**CASE #20-ZONEPA-0116 - STATEMENT OF COMPLIANCE WITH PLAN 2040
COMPREHENSIVE PLAN FOR LOUISVILLE METRO**

Location: 4805, 4809, 4811, 4813, 4901, and 4907 Bardstown Road
Proposed Use: Multi-Family Residential
Request: Zone Change from R-4 and C-1 to R-7

22-ZONE-0012

Figure 2.1 - Narrow Laurel Springs Dr bridge marked by hazard signs.

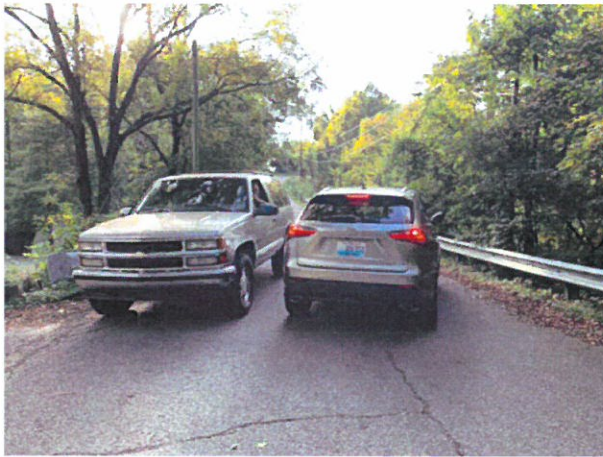
- Laurel Springs Dr is a narrow roadway with no sidewalks, no street lights, no bike lanes, and no public transportation access. See figure 2.1.
- Laurel Springs Dr is not taken care of by the city: no snow removal, no grass cutting

- The car and pedestrian entrance from Laurel Springs Dr be removed

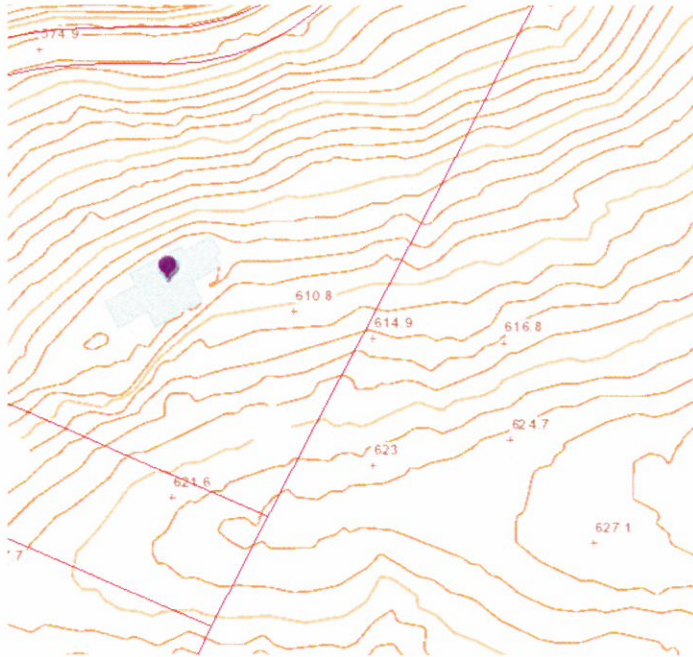
- According to section renderings, these massive 55-foot buildings are on land that is already 10 to 15-feet higher than adjacent properties. There may also be an additional 8-feet of backfill required (per geotechnical study and neighborhood meeting). Thus, these buildings will appear 78 feet to us who live below. See figure 3.1.

- For an *additional* 100-feet to be added to the setback along the North (Laurel Springs) and West (Walnut Hills Dr) sides of the property.
- Include a 6-foot berm with a 6-foot privacy fence and trees around the entire perimeter of the development at 4700 S Hurstbourne Pkwy and 4900 S Hurstbourne Pkwy.
- Leave the natural buffer along Laurel Spring Dr alone. See figure 3.4.

Figure 5.1 - 4700 S Hurstbourne Pkwy underground stream exiting at cliff 4819 Walnut Hills Dr (left), approximate location of sinkholes according to developer's plans, and the approximate location of sinkholes on abutting properties (right).

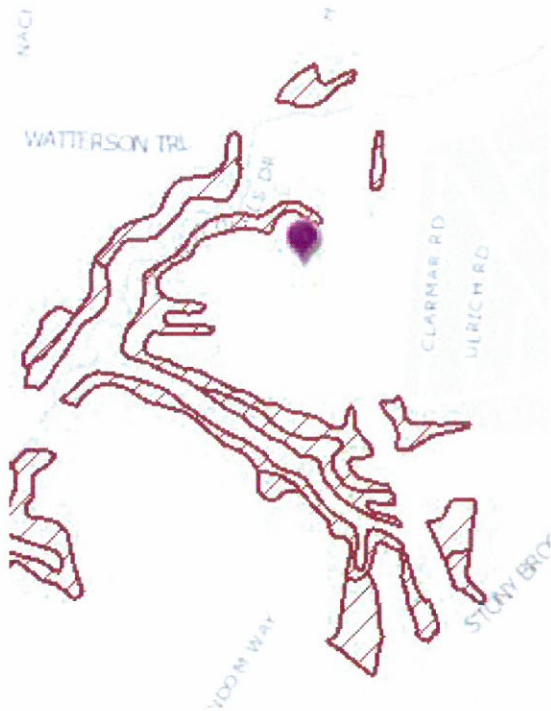
- There are sinkholes on abutting properties that are very close to the property line that the engineers failed to identify. In fact, we have reason to believe that one of these may be an underground cave or stream that flows from the 4700 S Hurstbourne Pkwy property, beneath a residents house, and ends up in the protected creek below. See figure 5.1

- For an unaffiliated third-party to conduct a geotechnical / impact study on the adjacent Walnut Hills and Laurel Springs properties.

Figure 2.2 - Two vehicles cannot safely pass each other on Laurel Springs Dr without maneuvering slowly to the side or backing up to make room.

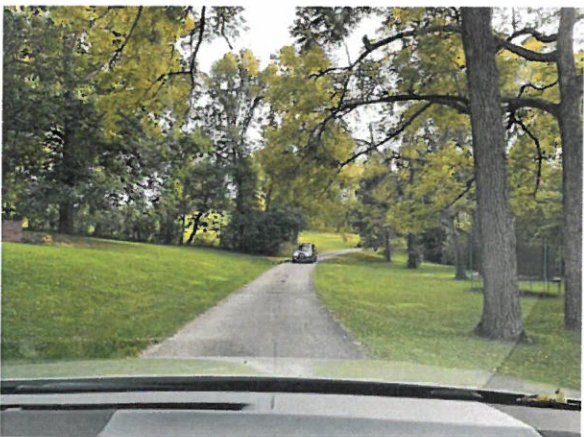
- Two cars cannot safely pass each other on Laurel Springs Dr. See figure 2.2.
- Walnut Hills Dr is a one-lane road with no sidewalks, no street lights, and no bike lanes. See figure 2.3.

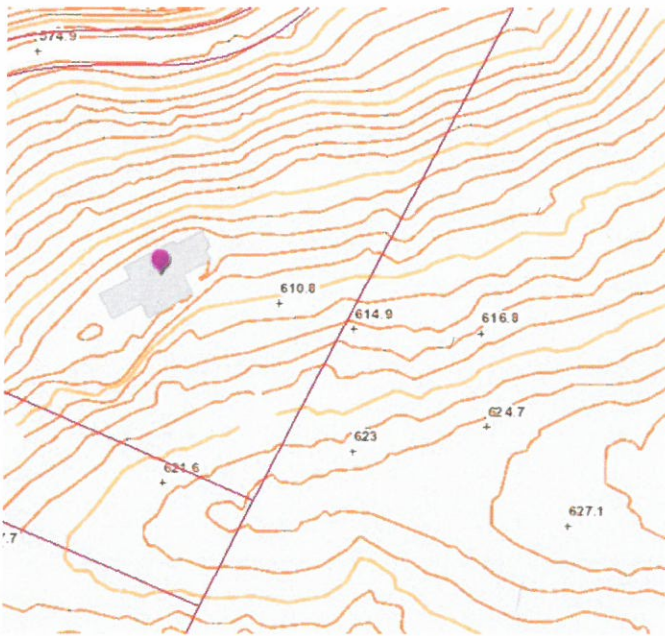
- According to section renderings, these massive 55-foot buildings are on land that is already 10 to 15-feet higher than adjacent properties. There may also be an additional 8-feet of backfill required (per geotechnical study and neighborhood meeting). Thus, these buildings will appear 78 feet to us who live below. See figure 3.1.

- For an *additional* 100-feet to be added to the setback along the North (Laurel Springs) and West (Walnut Hills Dr) sides of the property.
- Include a 6-foot berm with a 6-foot privacy fence and trees around the entire perimeter of the development at 4700 S Hurstbourne Pkwy and 4900 S Hurstbourne Pkwy.
- Leave the natural buffer along Laurel Spring Dr alone. See figure 3.4.

Figure 5.1 - 4700 S Hurstbourne Pkwy underground stream exiting at cliff 4819 Walnut Hills Dr (left), approximate location of sinkholes according to developer's plans, and the approximate location of sinkholes on abutting properties (right).

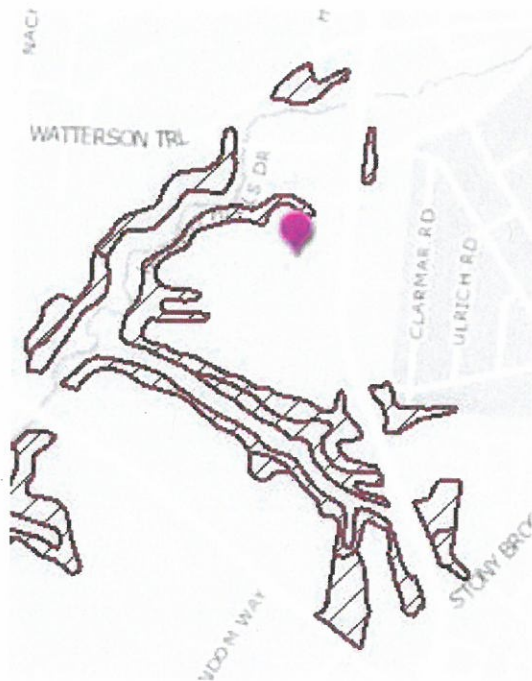
- There are sinkholes on abutting properties that are very close to the property line that the engineers failed to identify. In fact, we have reason to believe that one of these may be an underground cave or stream that flows from the 4700 S Hurstbourne Pkwy property, beneath a residents house, and ends up in the protected creek below. See figure 5.1

- For an unaffiliated third-party to conduct a geotechnical / impact study on the adjacent Walnut Hills and Laurel Springs properties.

KENNETH & KAREN HABENSTEIN
4805 WALNUT HILLS DR
T.B. 44 LOT 502
D.B. 5803 PG. 367
NFD/R4

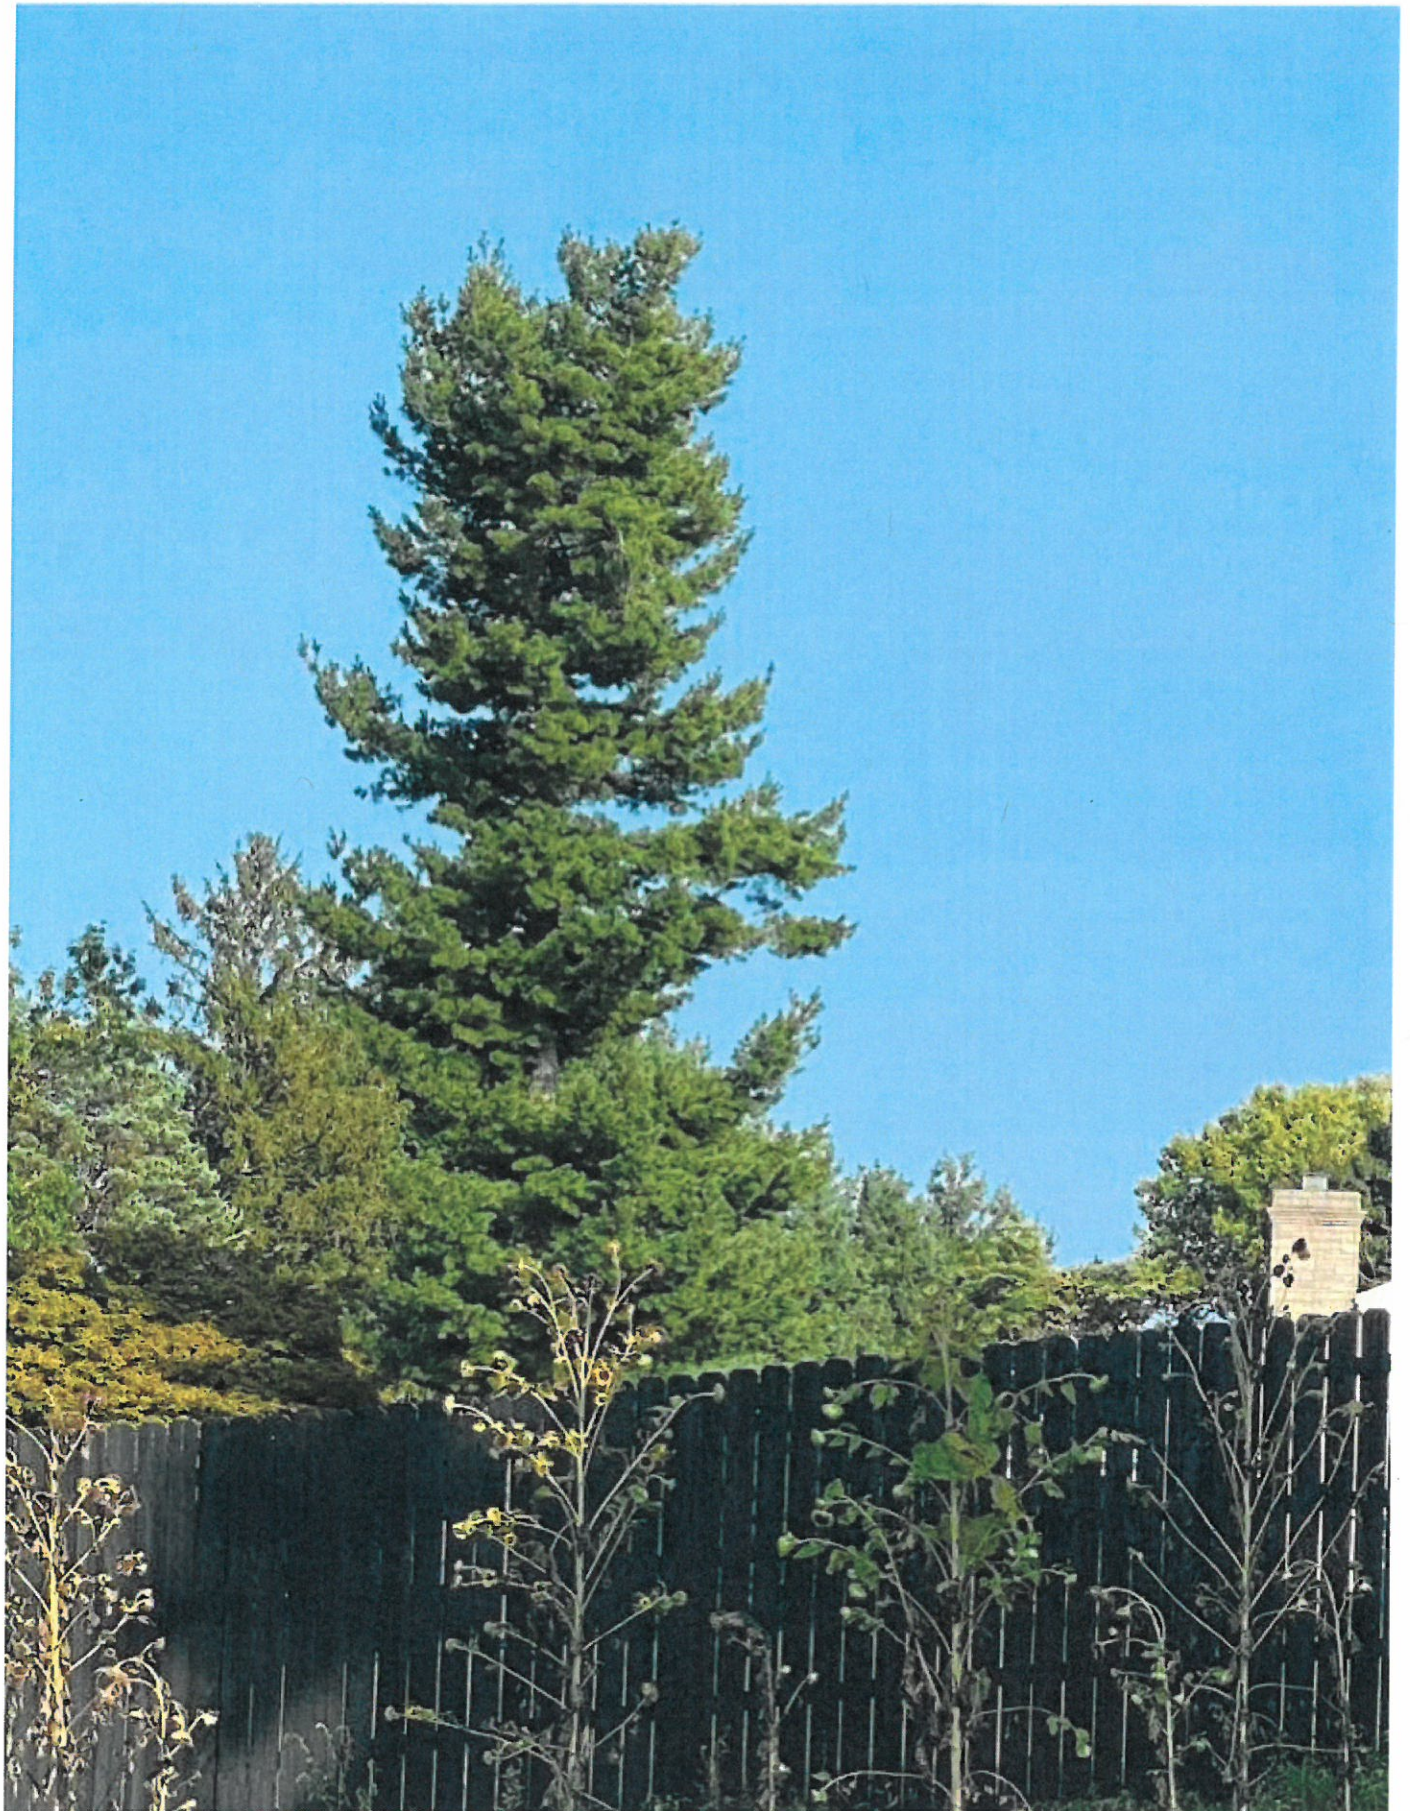
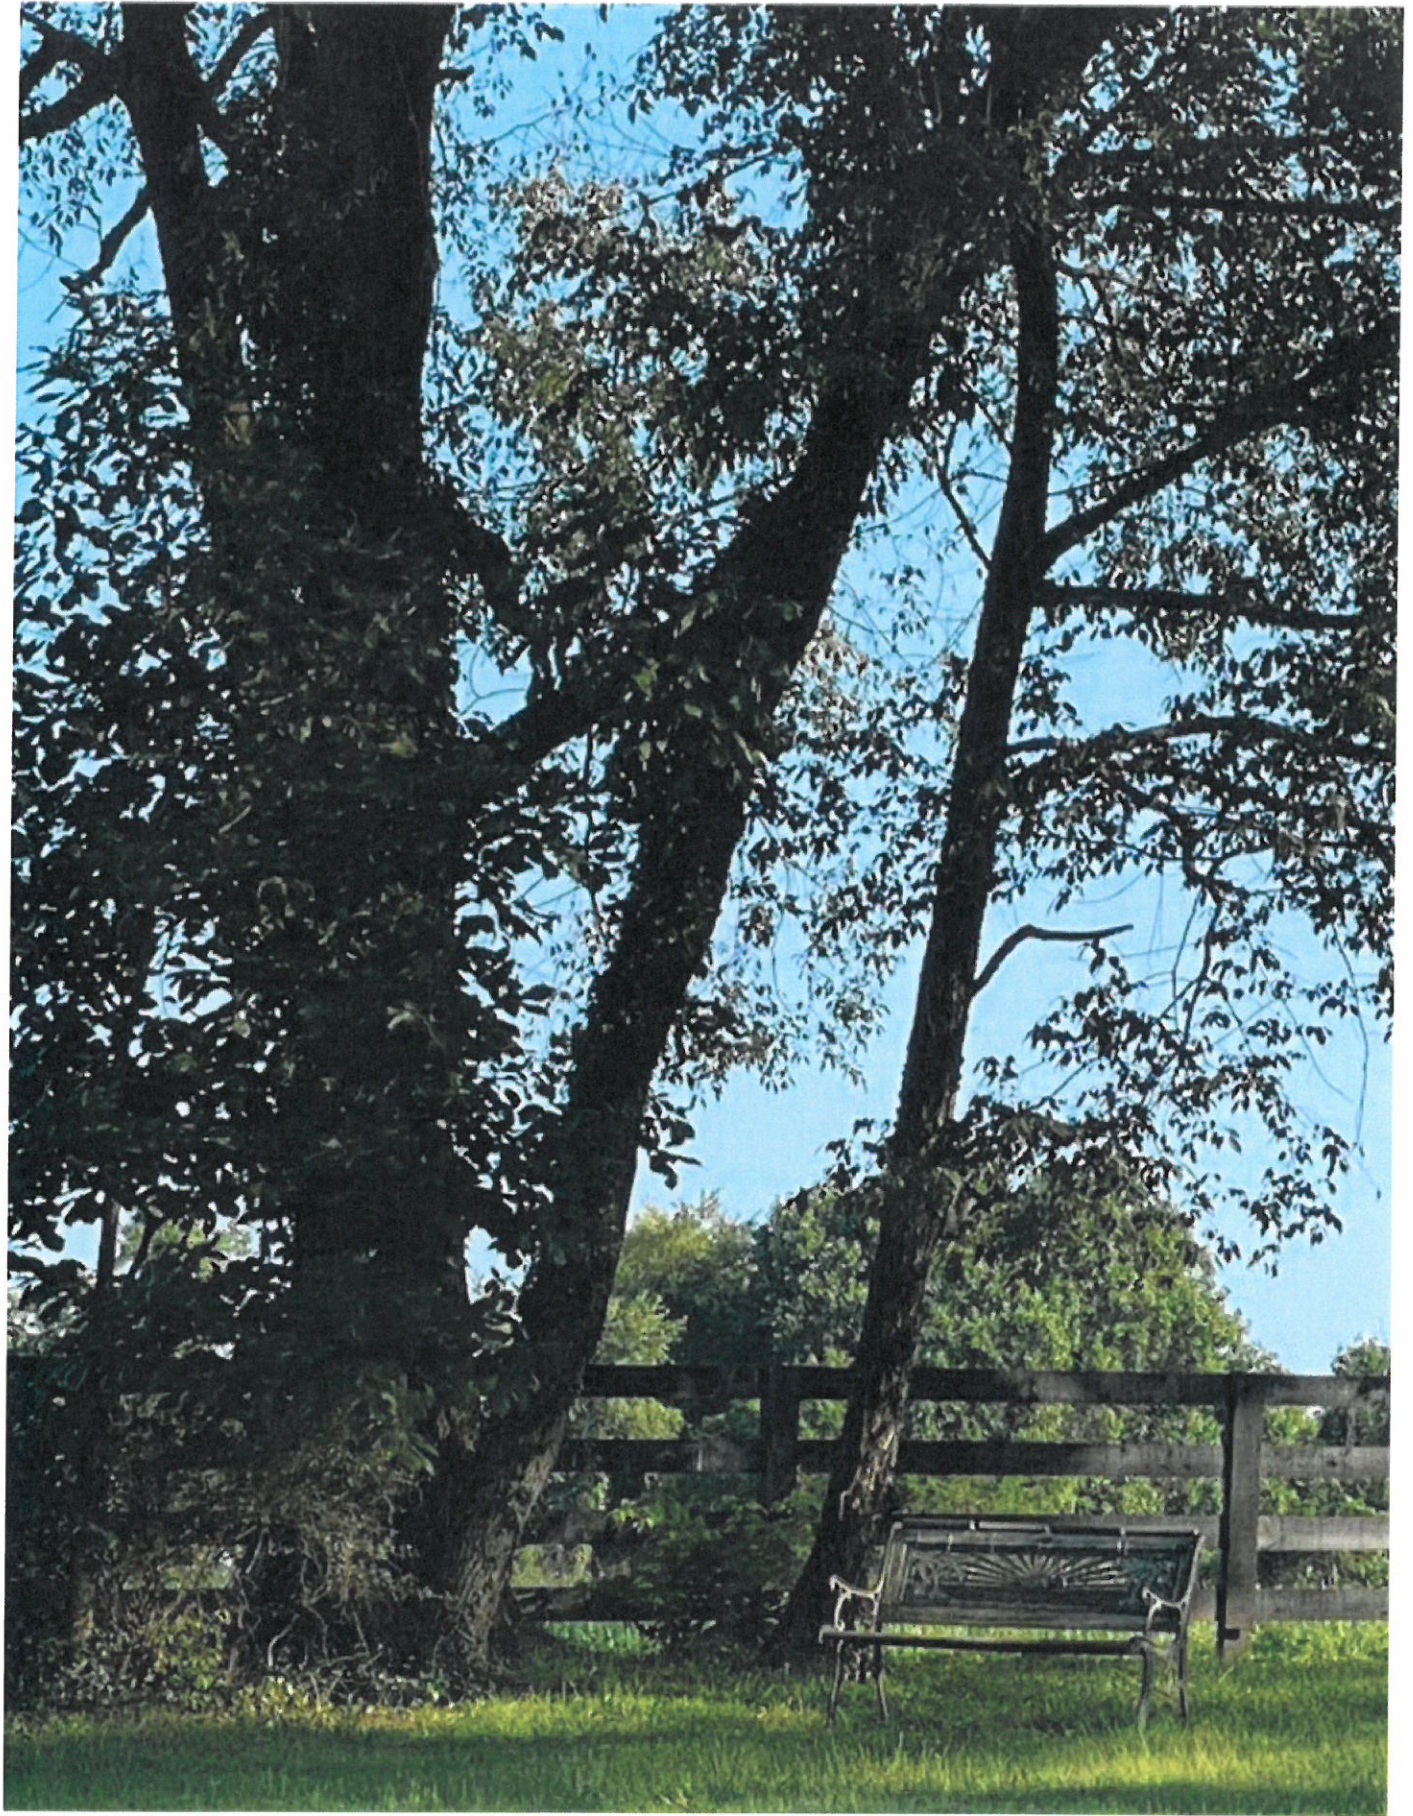
First and foremost, the developer has proposed 3-story and 4-story buildings towering over my home, with only a 6-foot fence to set us apart. These buildings are literally right on top of my home and the balconies will be looking directly into all my bedrooms, living room, and kitchen, in addition to my outdoor patio area, which is very important to us.

Because my home is downhill from these buildings, they will appear even larger from my view as my home is sloped downhill from this development.

The proposed development has a density of nearly 19.49 dwelling units per acre. The abutting properties on Walnut Hills Dr have a density 0.5 dwelling units per acre. That is a drastic change and violates the above requirement.
